ADDENDUM NUMBER 1

DATE: 11/14/2024

PROJECT: Clinton Twp. Fire Station Renovations

PROJECT NUMBER: 0242-0451

A412

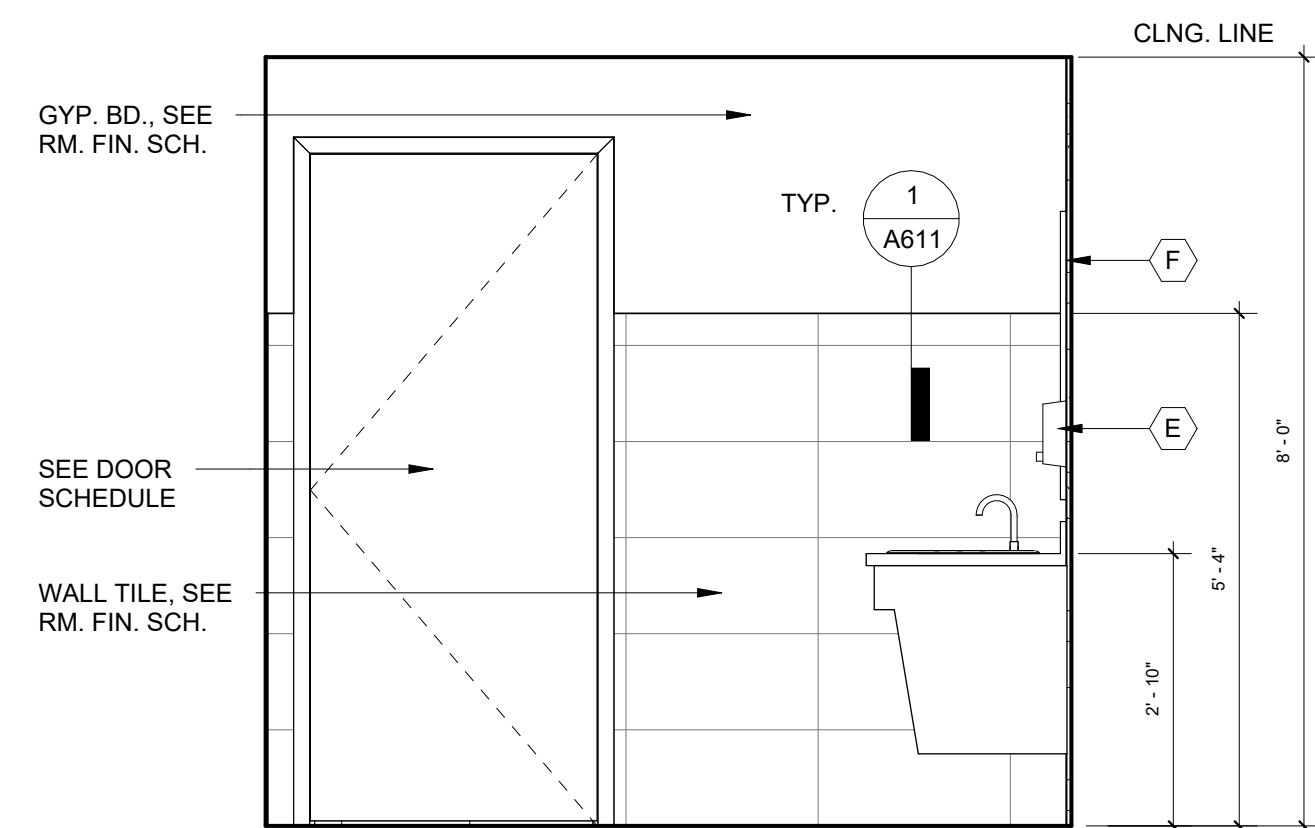
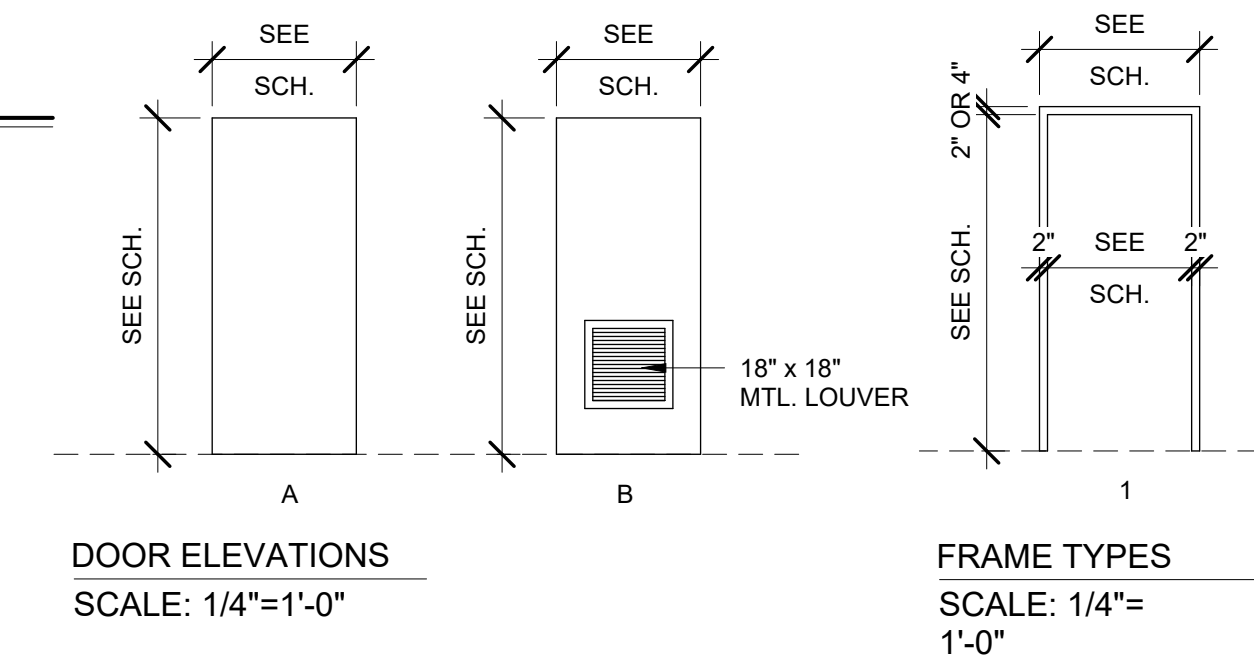
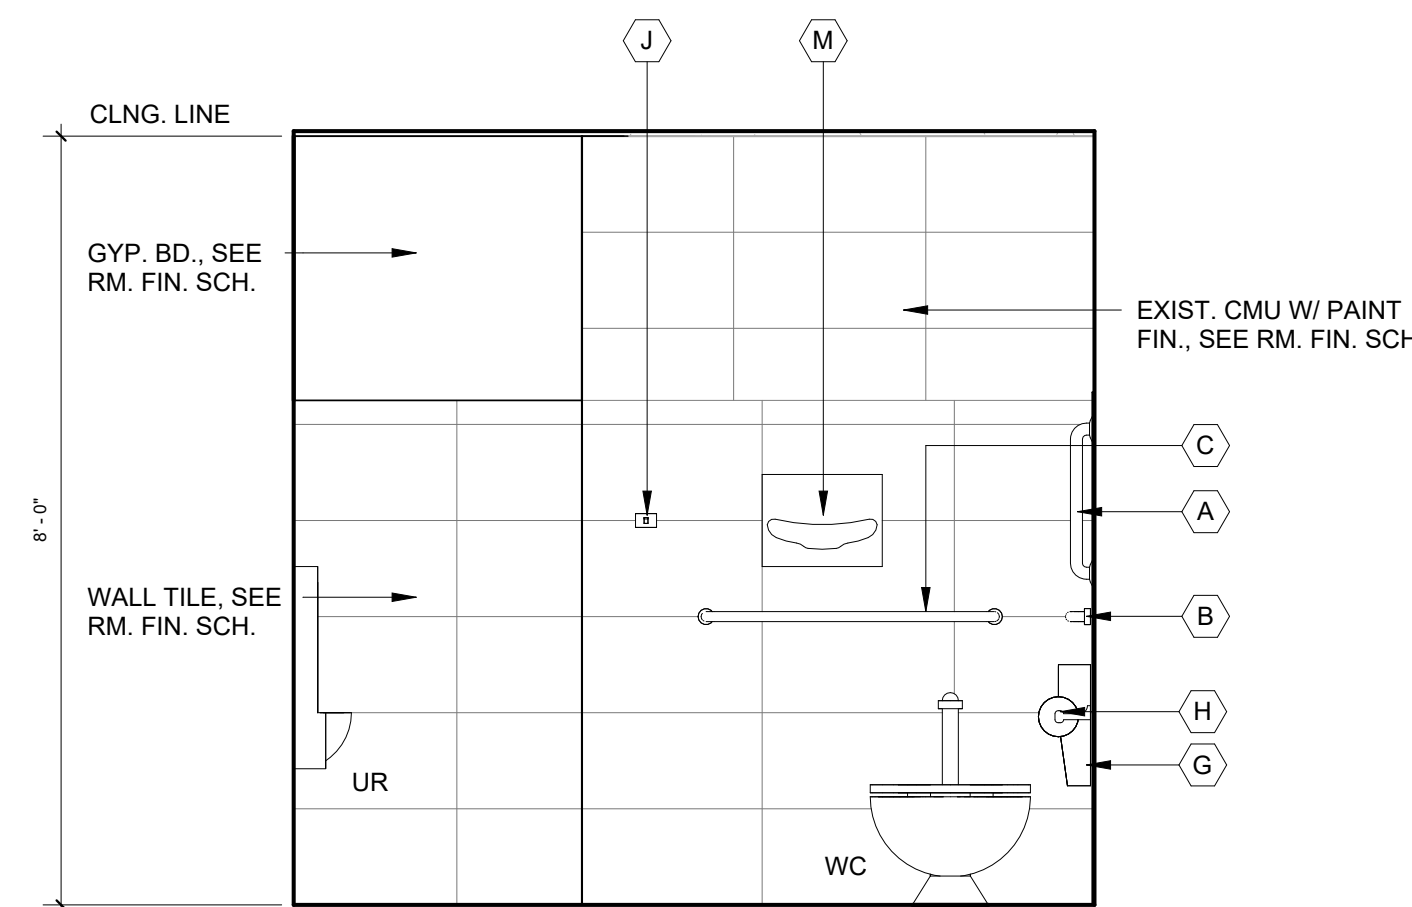
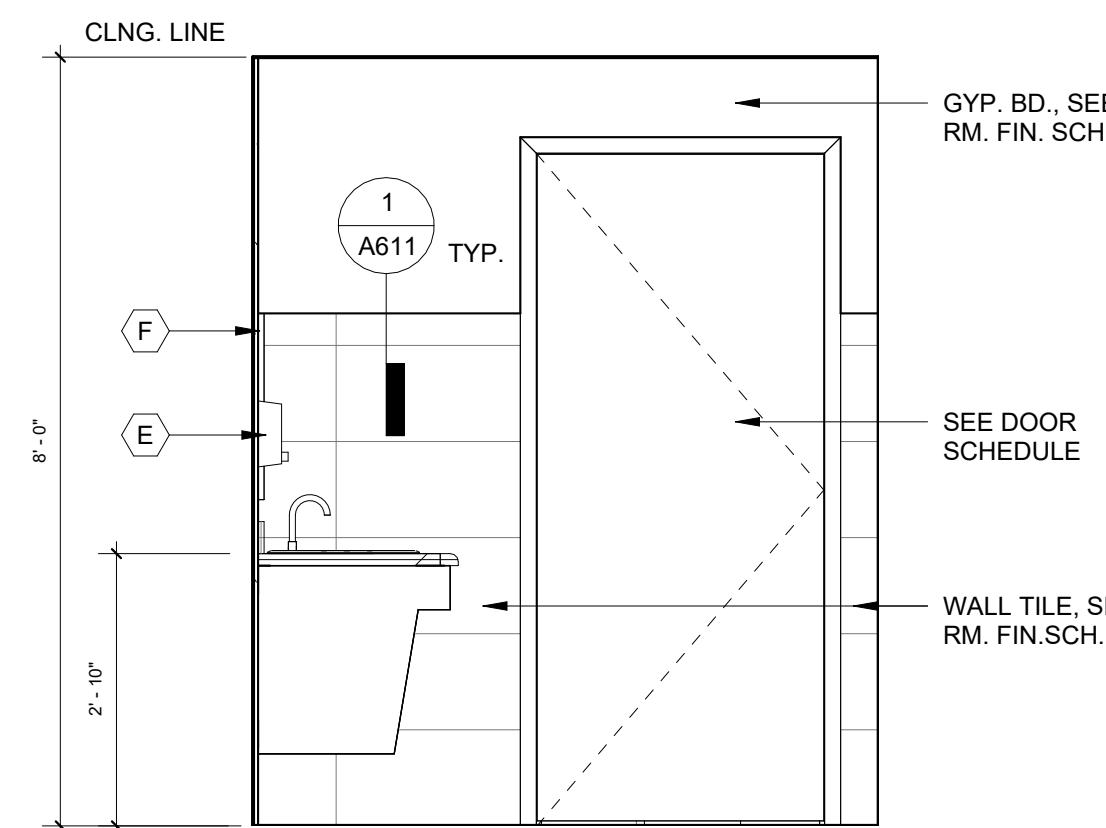
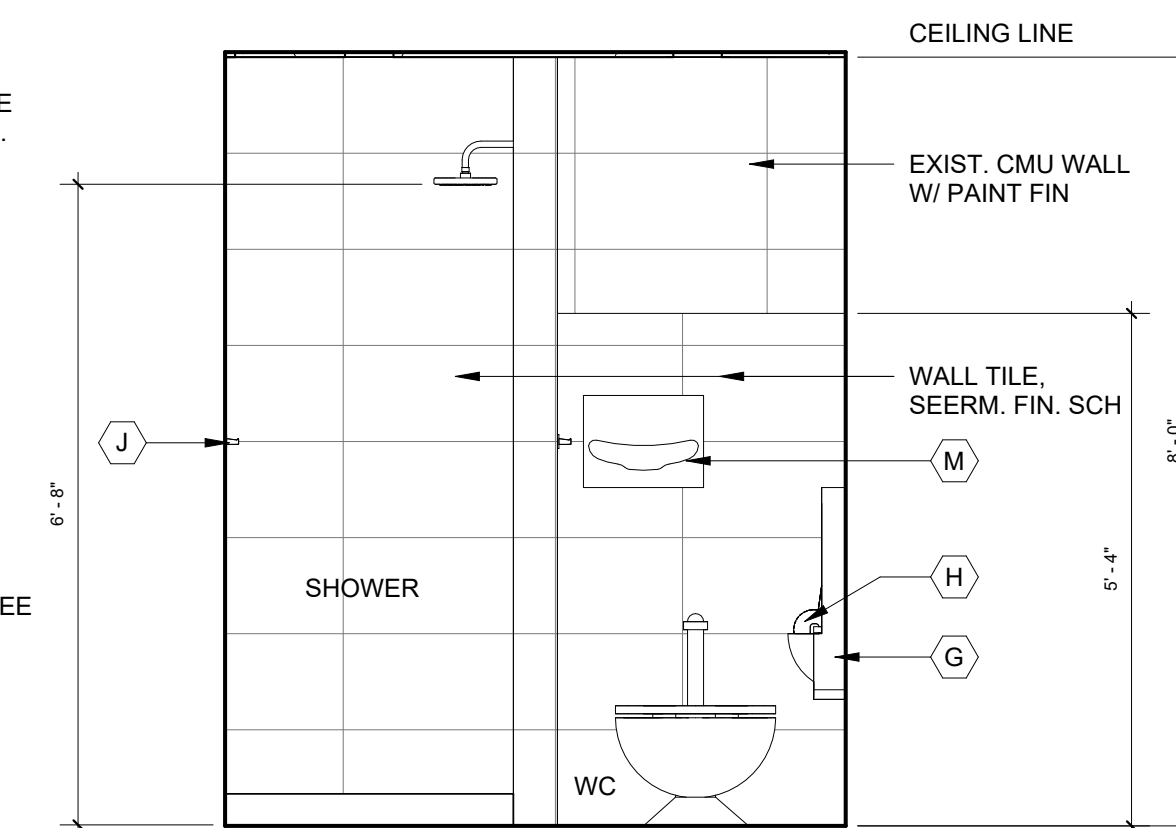
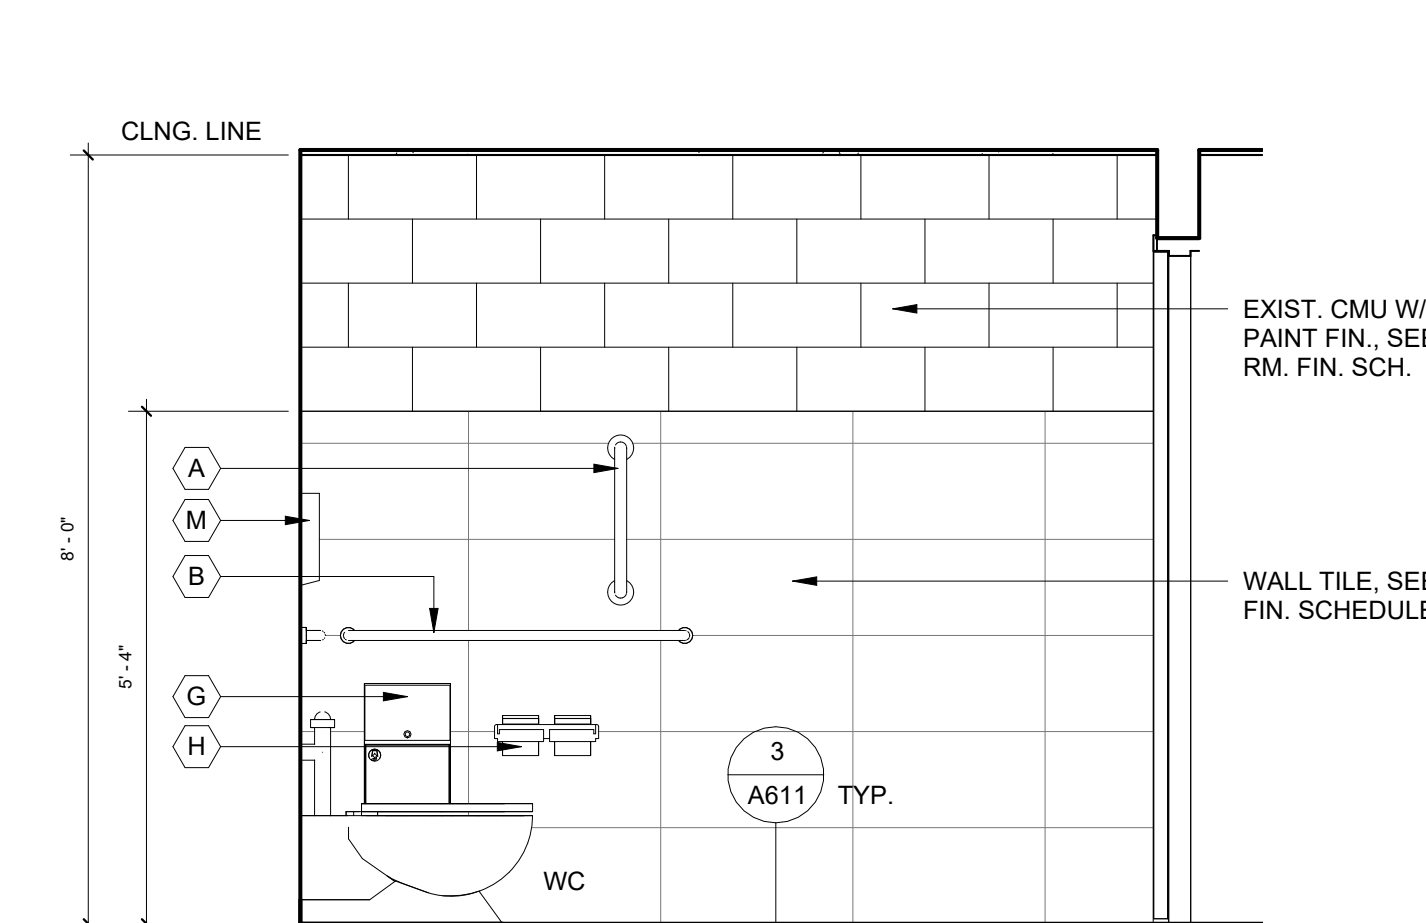
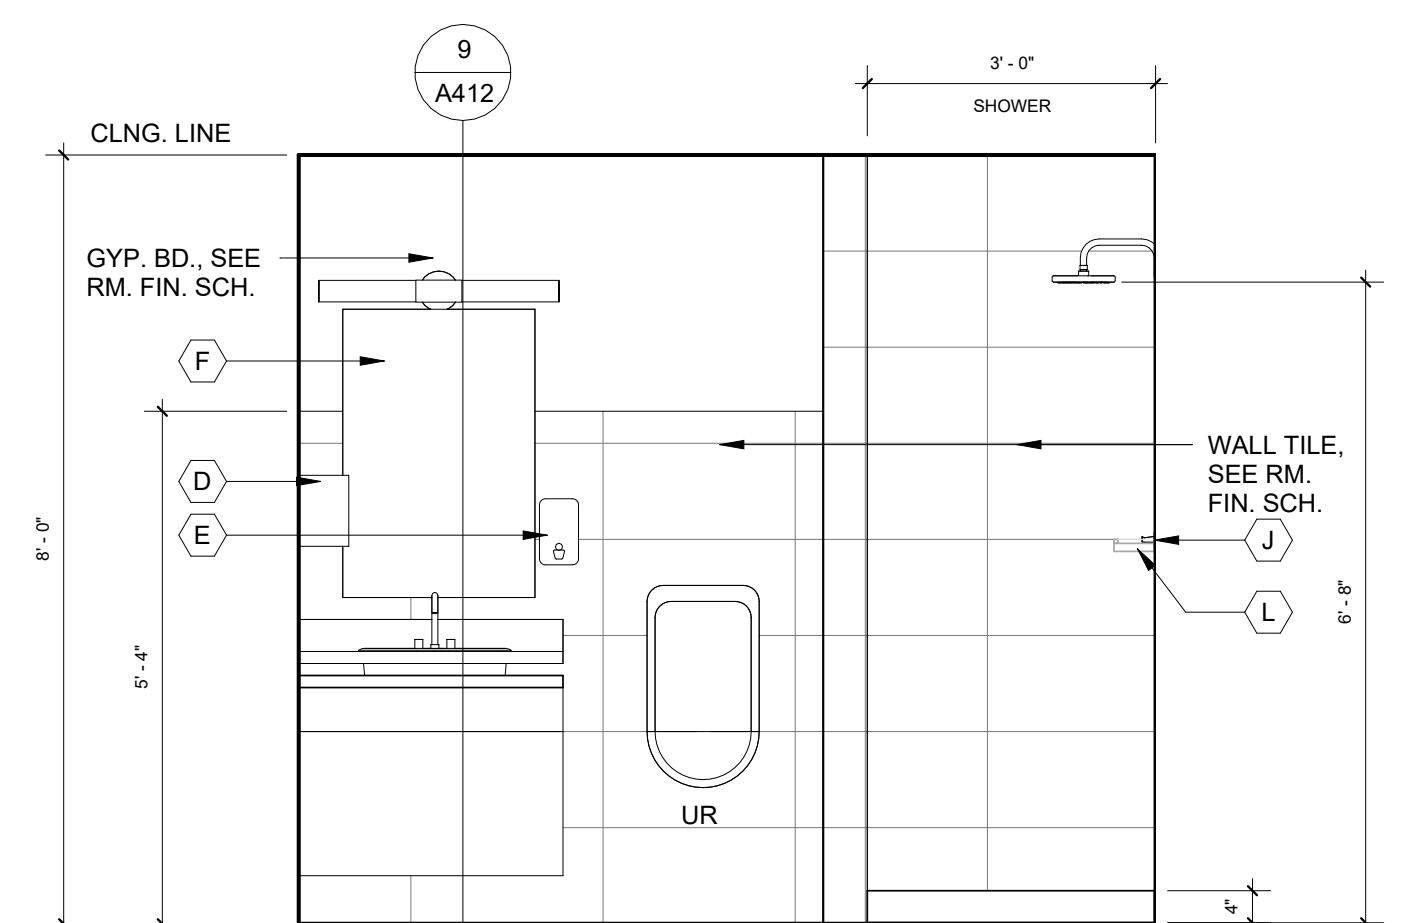
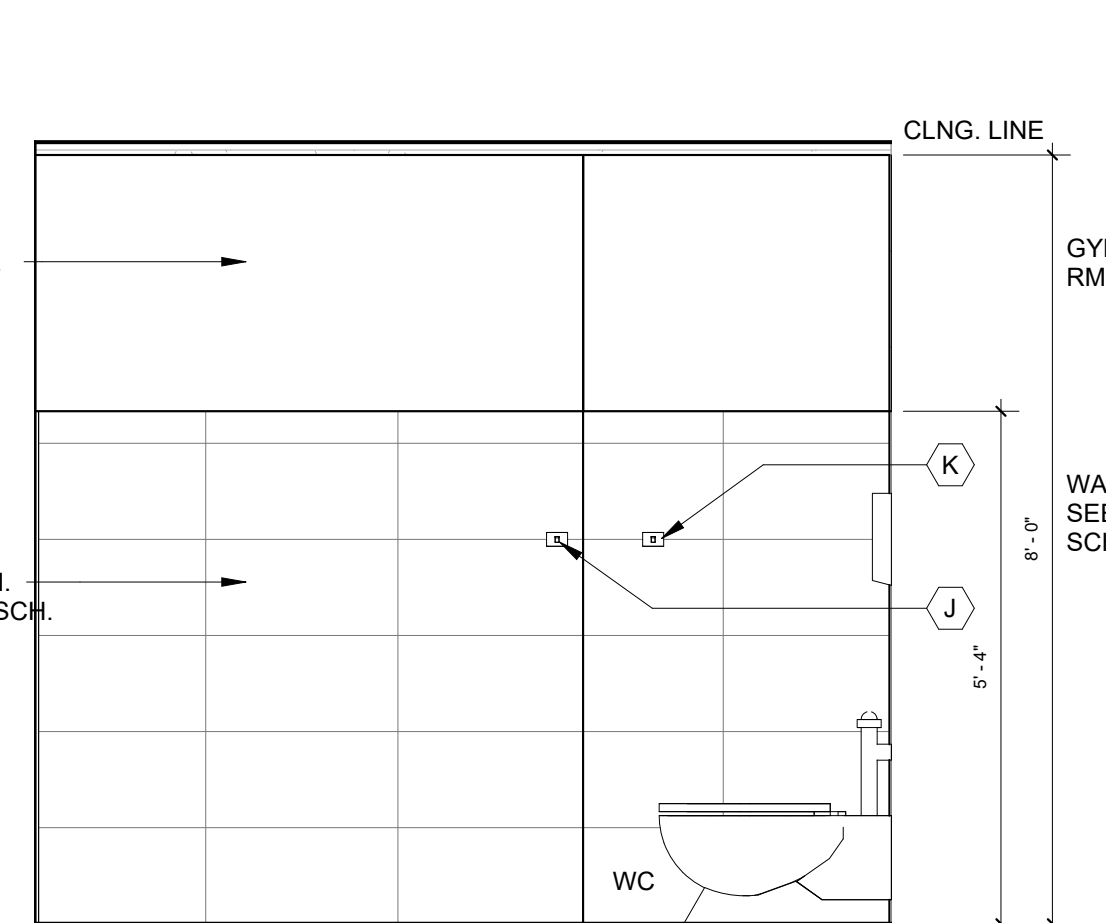
10. Q: Per page A412, please clarify the floor tile type to be used regarding the 12x24 sizing.
A: For the area within the showers use 2"x2" mosaic version of the same tile.

1. SHEET A032: (reissued)
 - a. Revised Mechanical/Plumbing specifications.
2. SHEET A412: (reissued)
 - a. Revised lavatory dimensions.
